23 September 2022

GS#610-012 MCM LeFleur's Bluff Park Improvements (Phase 2)
Mississippi Department of Wildlife, Fisheries, and Parks

ADDENDUM NO. 02

R101

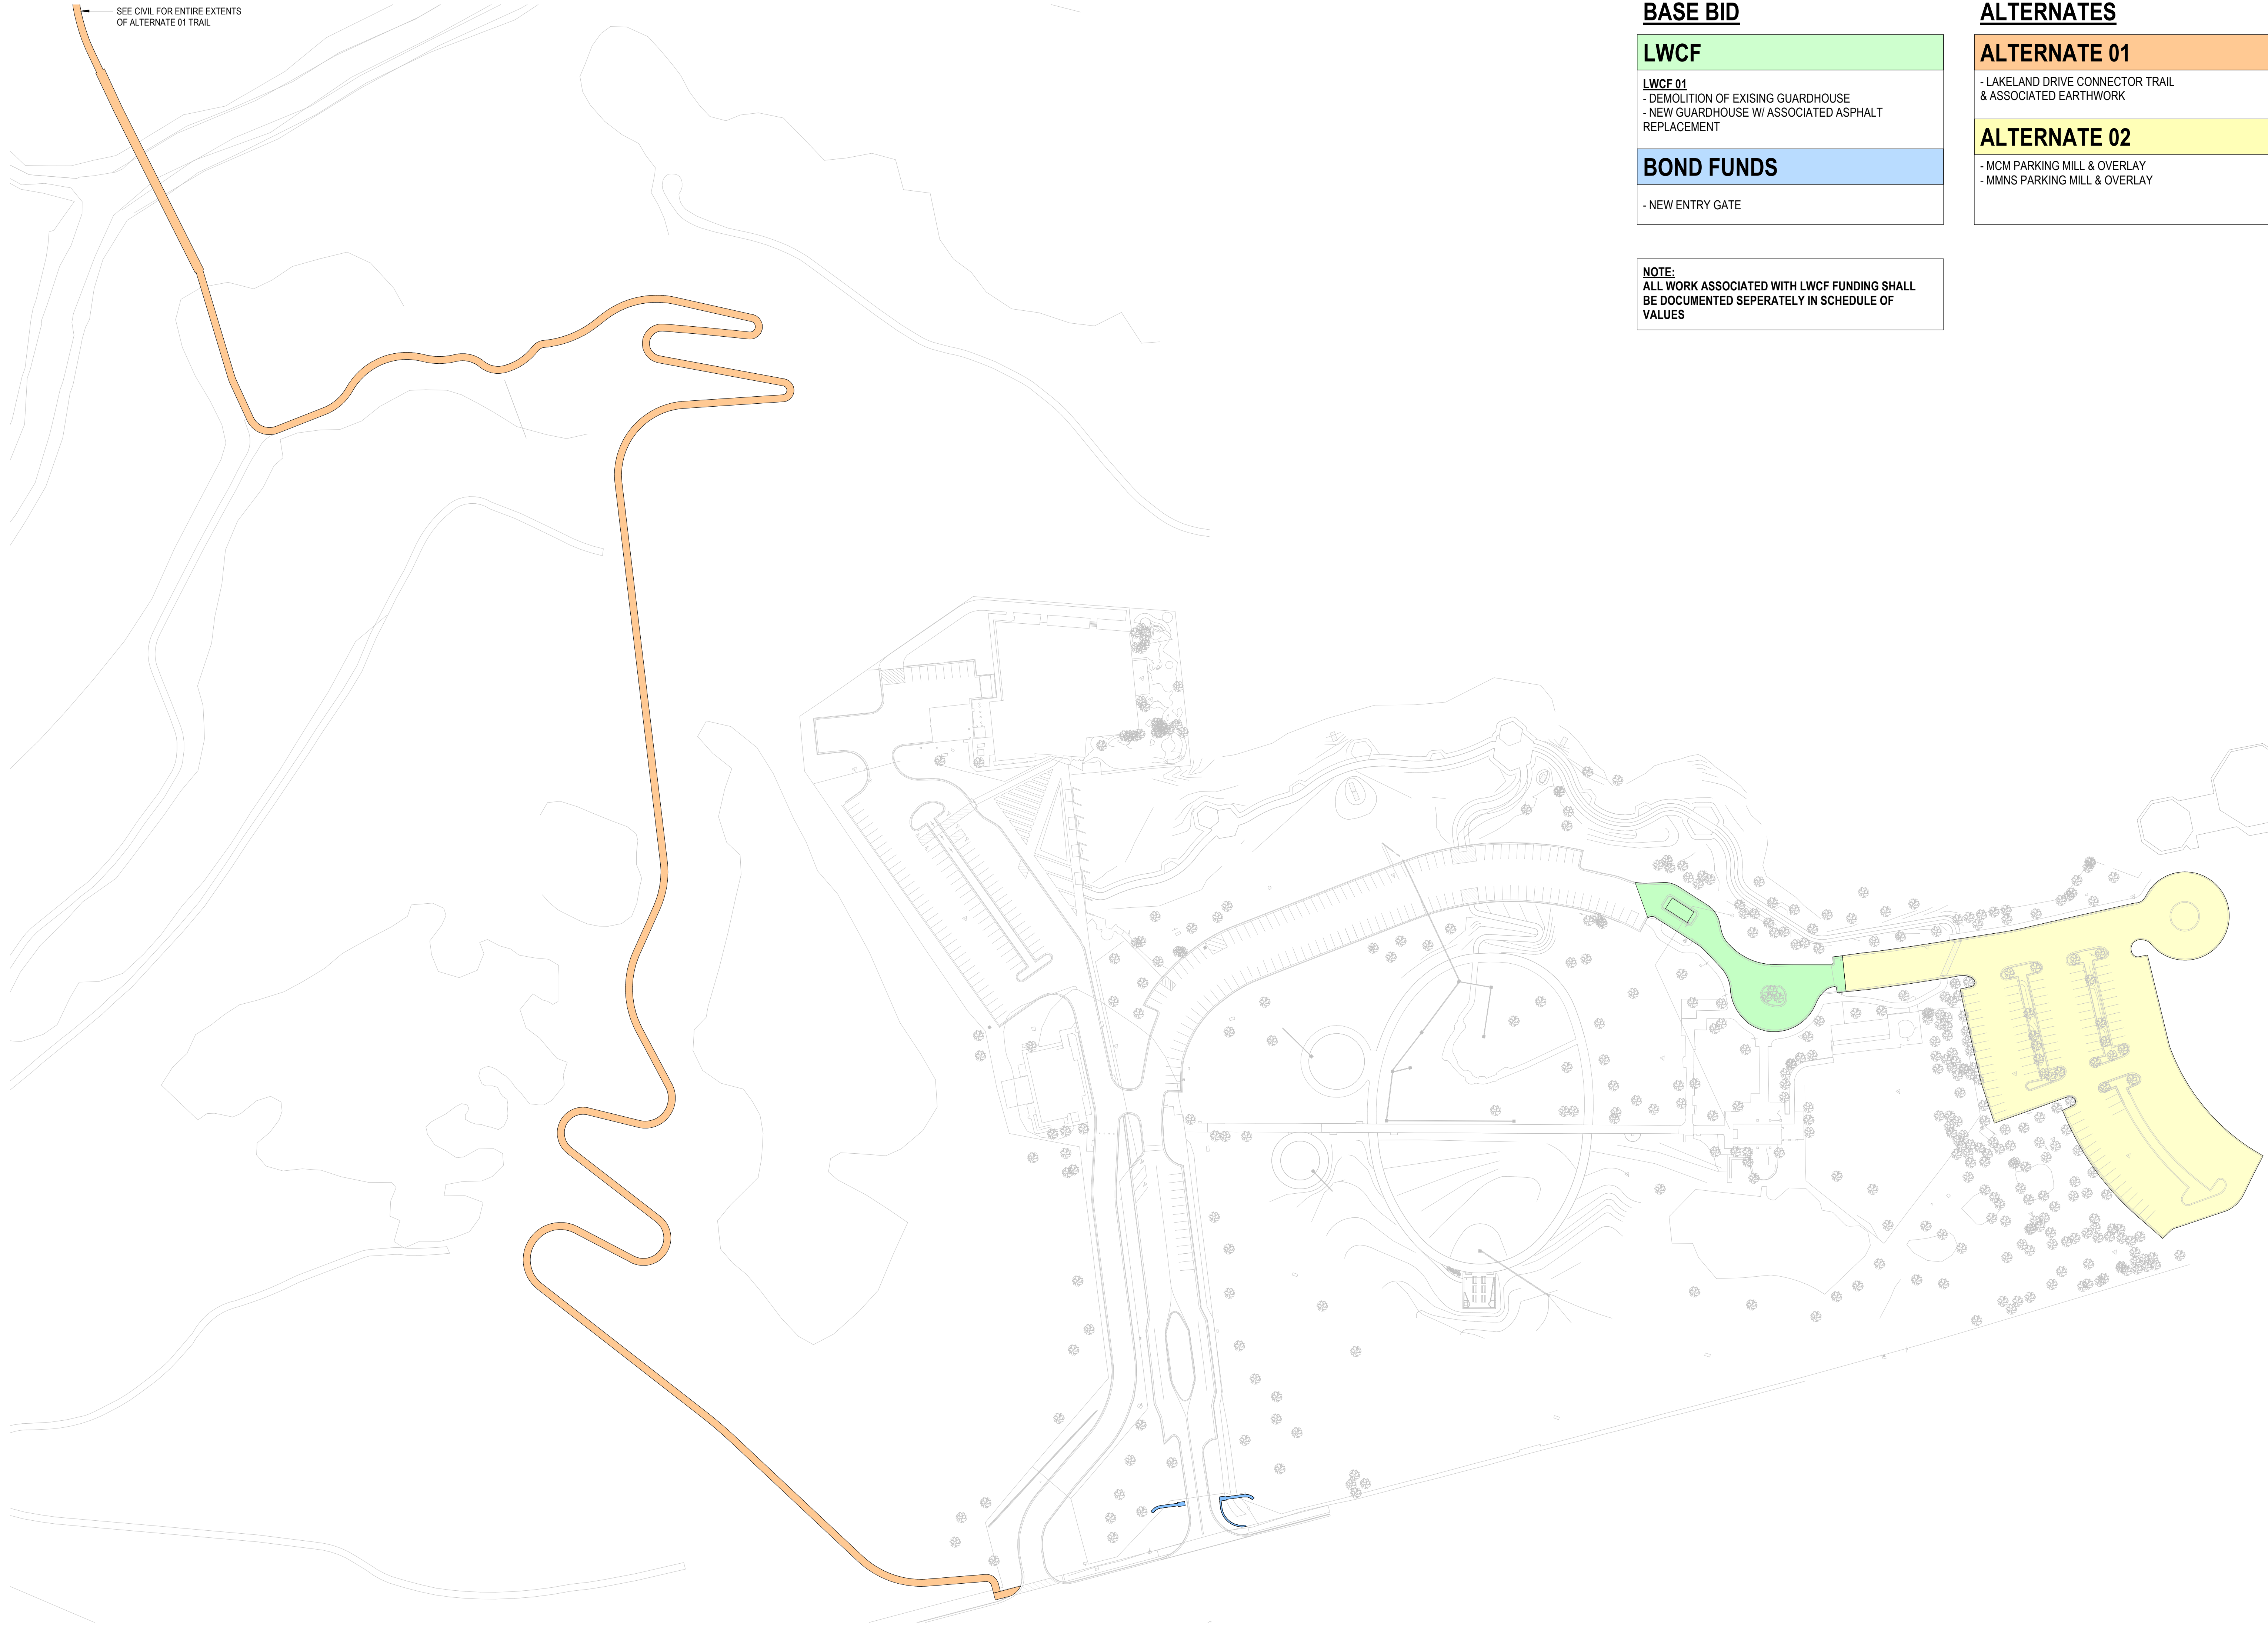
ITEM NO. 03 **R101 – PHASING PLAN**
REPLACE sheet with the attached **R101.**
REVISES the scope of work included in documents.

C200
EXISTING CONDITIONS &
DEMOLITION PLAN -
BASE BID

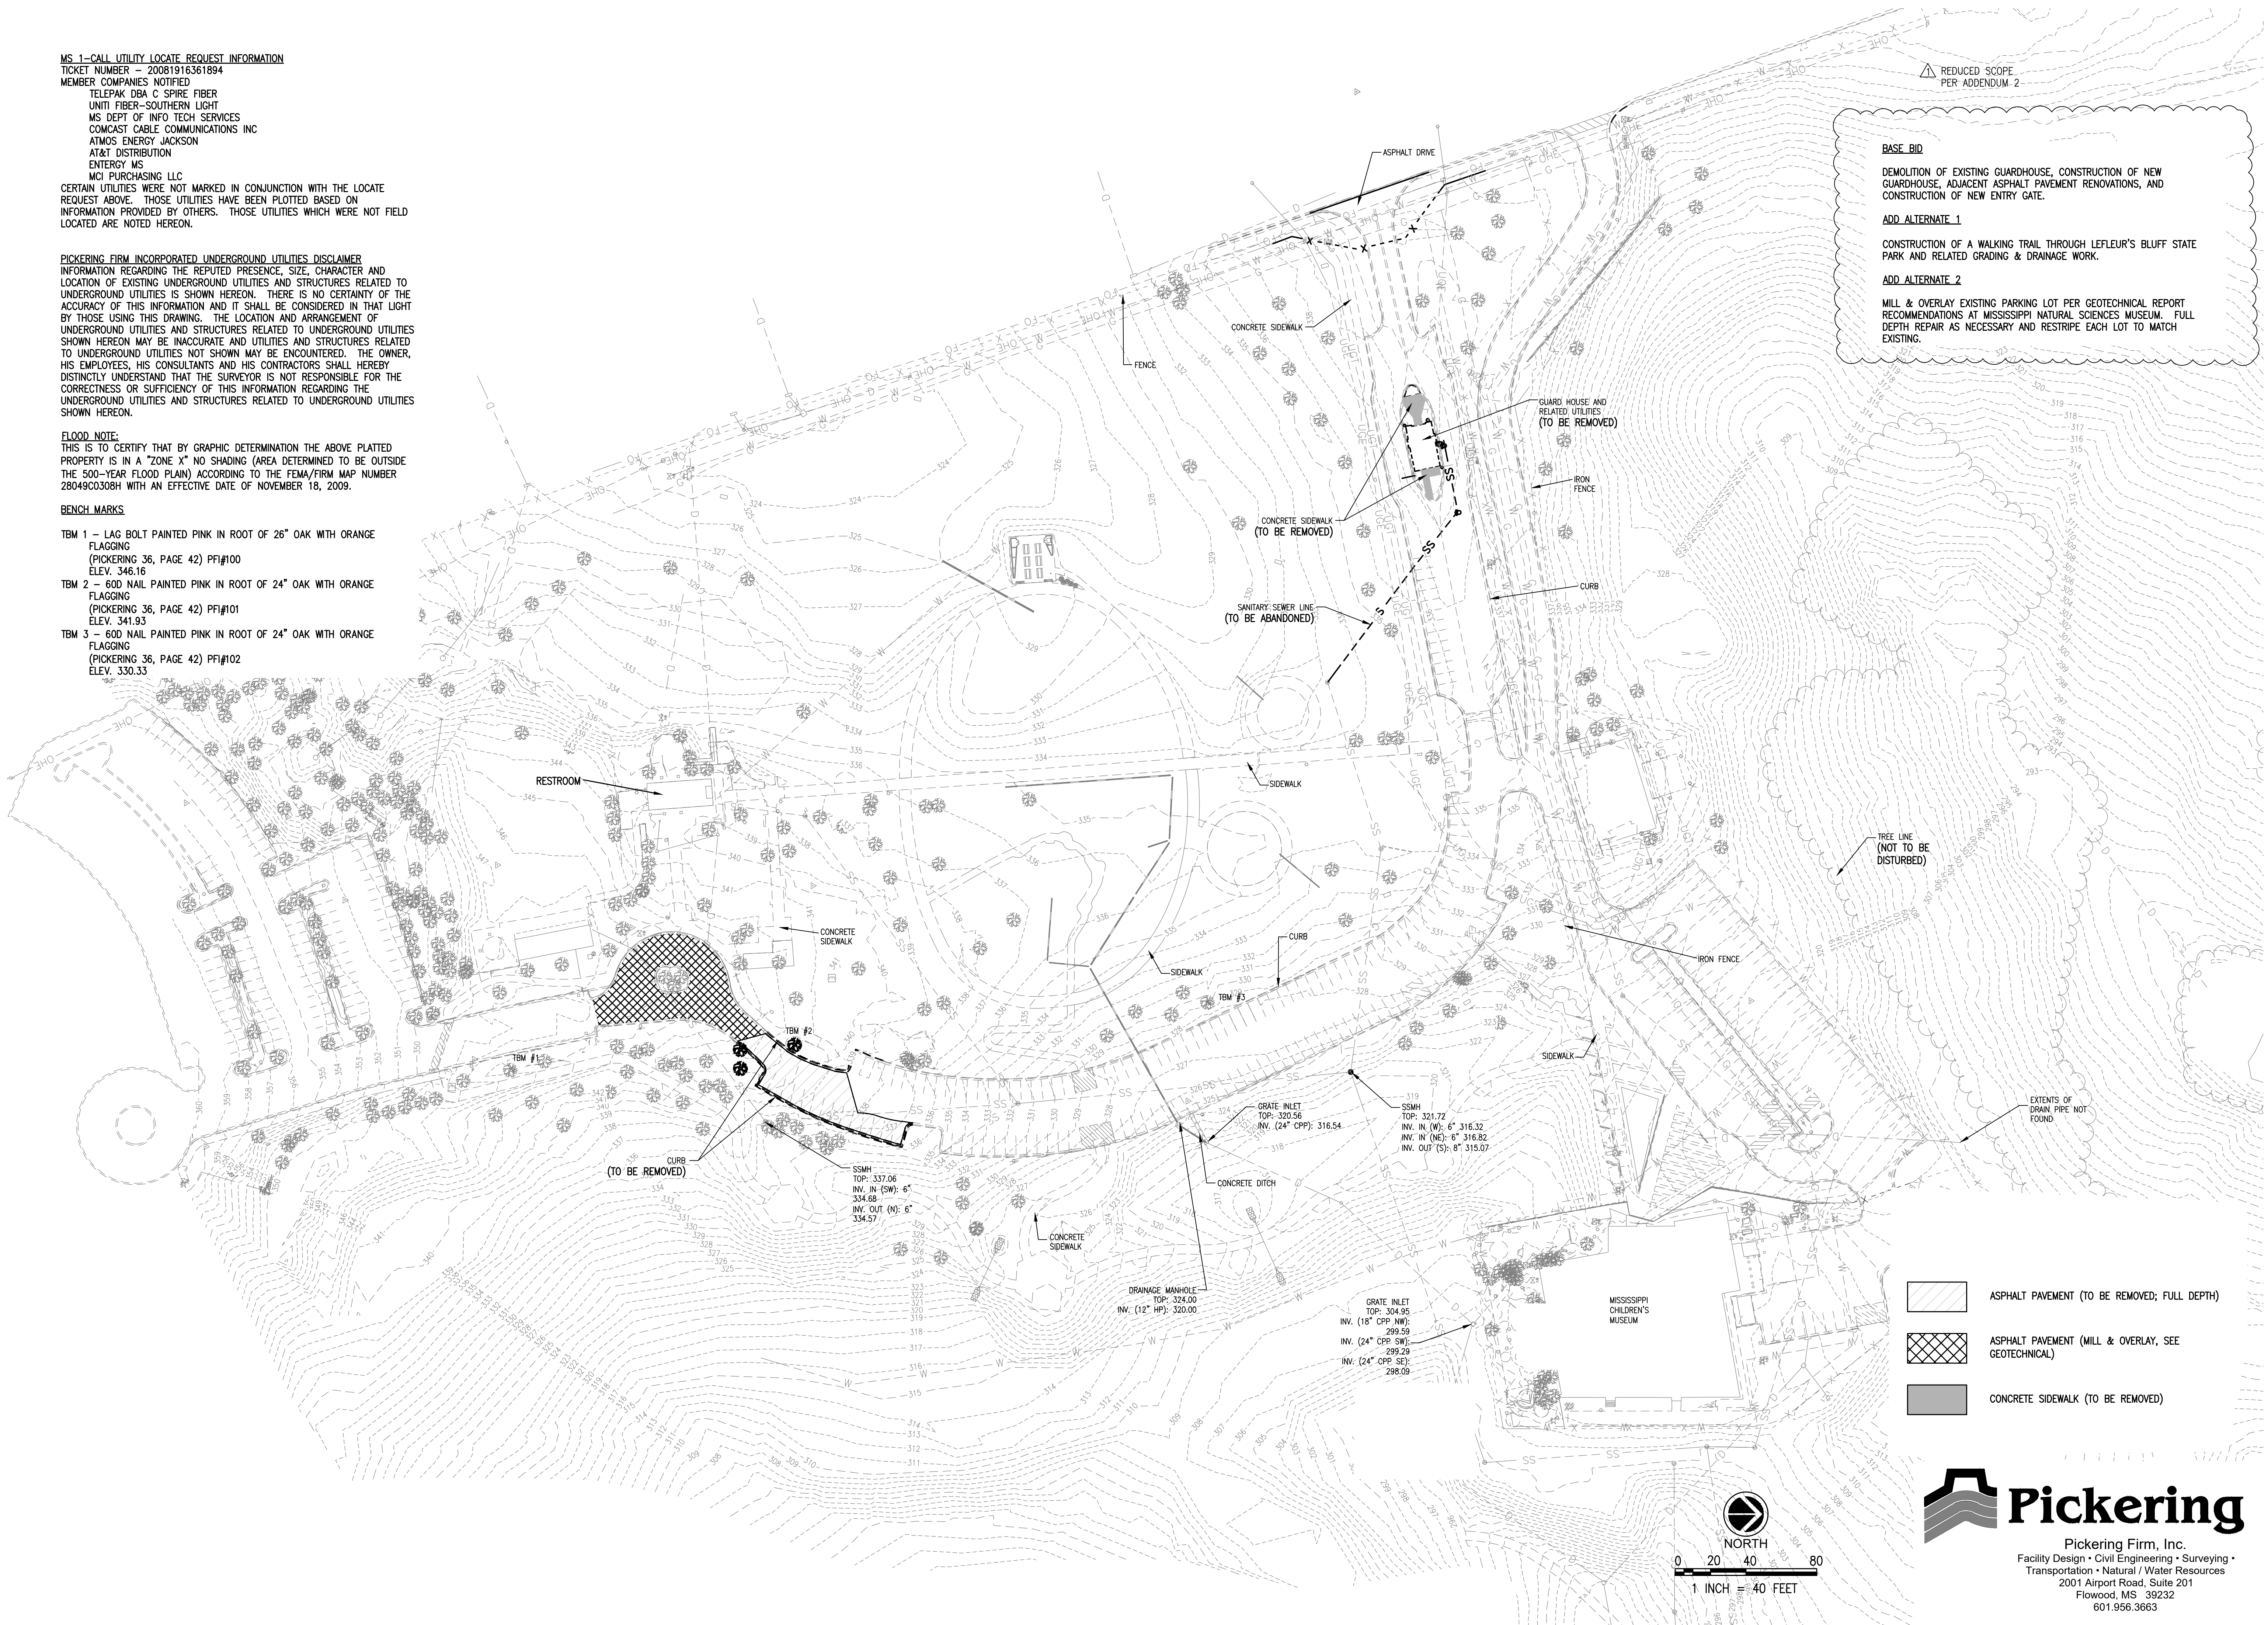
ITEM NO. 04 **C200 – EXISTING CONDITIONS & DEMOLITION PLAN – BASE BID**
REPLACE sheet with the attached **C200.**
REVISES Base Bid by removing scope of work.

REDUCED SCOPE
PER ADDENDUM 2

EXISTING CONDITIONS &
DEMOLITION PLAN - ADD
ALTERNATE 2 - PARKING
REPAIR

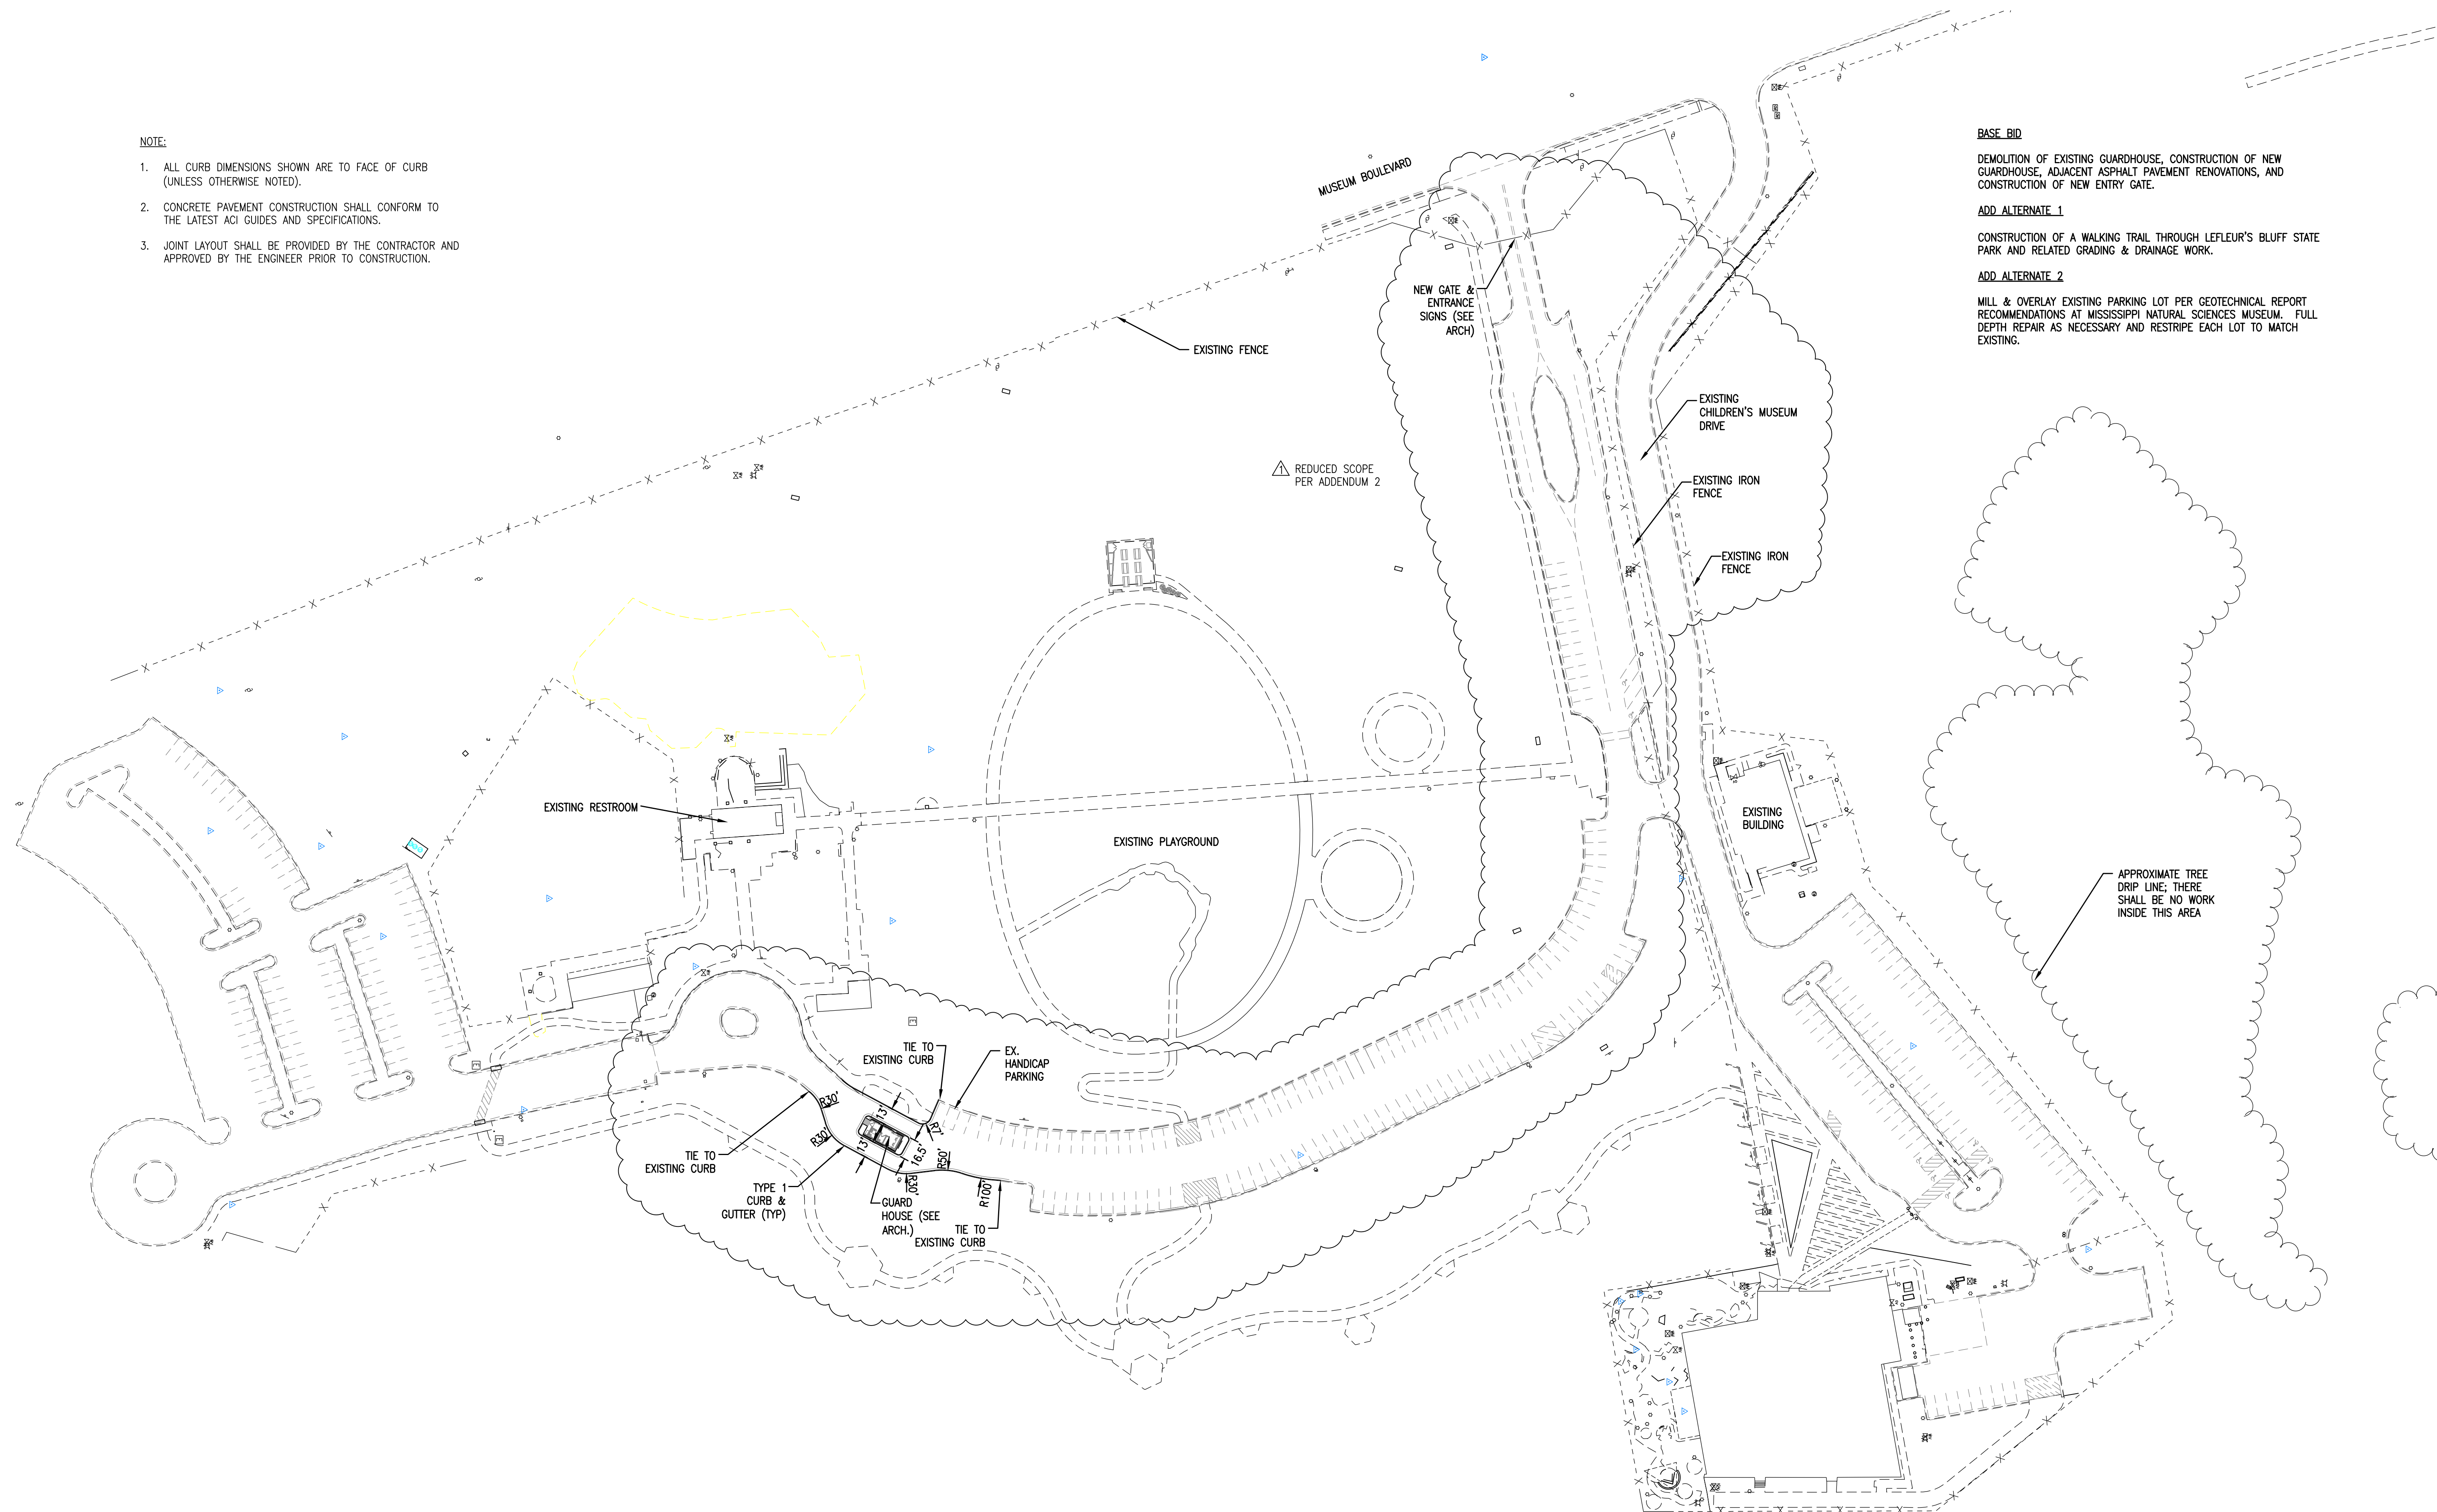
- ITEM NO. 06** **C202 – EXISTING CONDITIONS & DEMOLITION PLAN – ADD ALTERNATE 2 – PARKING REPAIR**
REPLACE sheet with the attached C202.
REVISES Alternate 02 by removing work associated with Mississippi Children’s Museum parking lot.
REMOVES Alternate 03 entirely.
